CONNECTICUT COALITION AGAINST MILLSTONE

March 2, 2005

Re: Millstone Nuclear Power Station/Draft Environmental Impact Statement

Figure 6-1
Strontium-90 in Milk

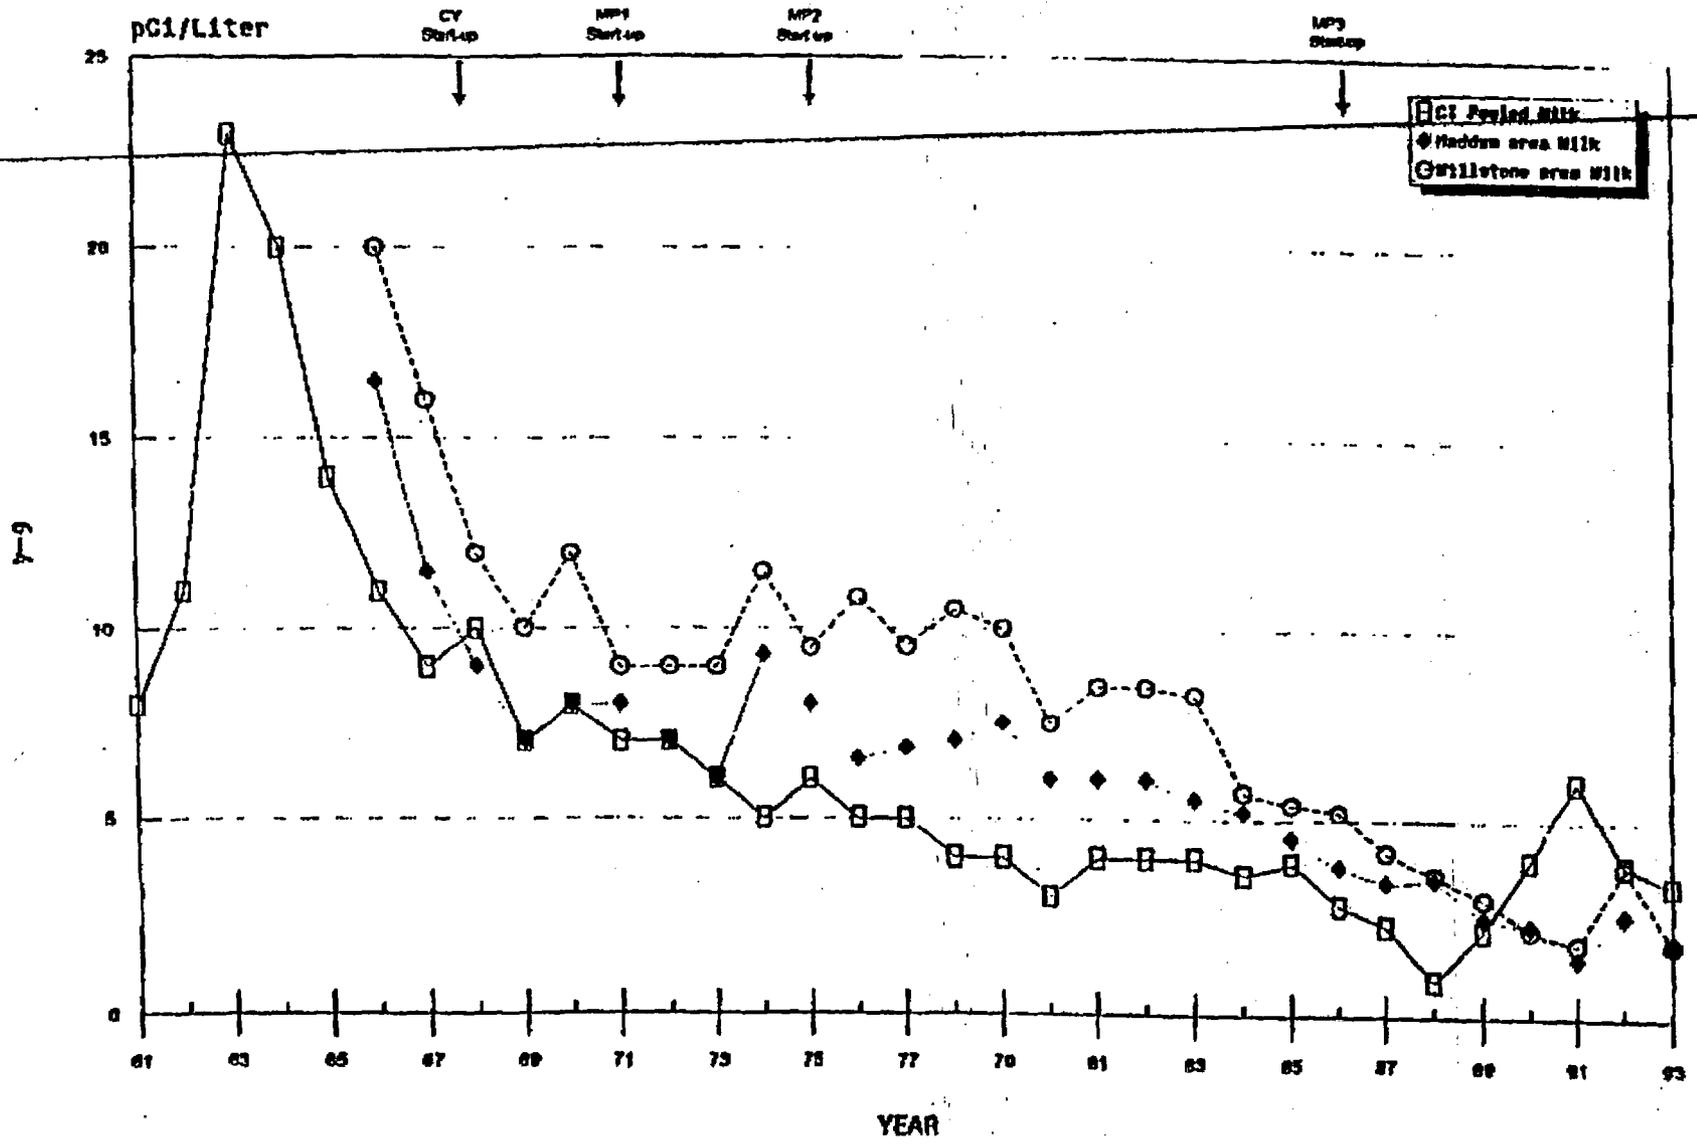
Attached to Dr. Sternglass' report are measurements, reported to the NRC by Dominion, of strontium-90 in goat milk sampled at locations within 5 miles of Millstone during the years 2001, 2002 and 2003.

The reported samples of measurements show concentrations of 13 to 14 pCi/l on other days during the three-year period. According to Dr. Sternglass, these are also significantly high readings since strontium-90, concentrating in milk due to atmospheric nuclear weapons testing which ended in 1980, has declined to less than 1 pCi/l in areas far removed from any nuclear reactors.
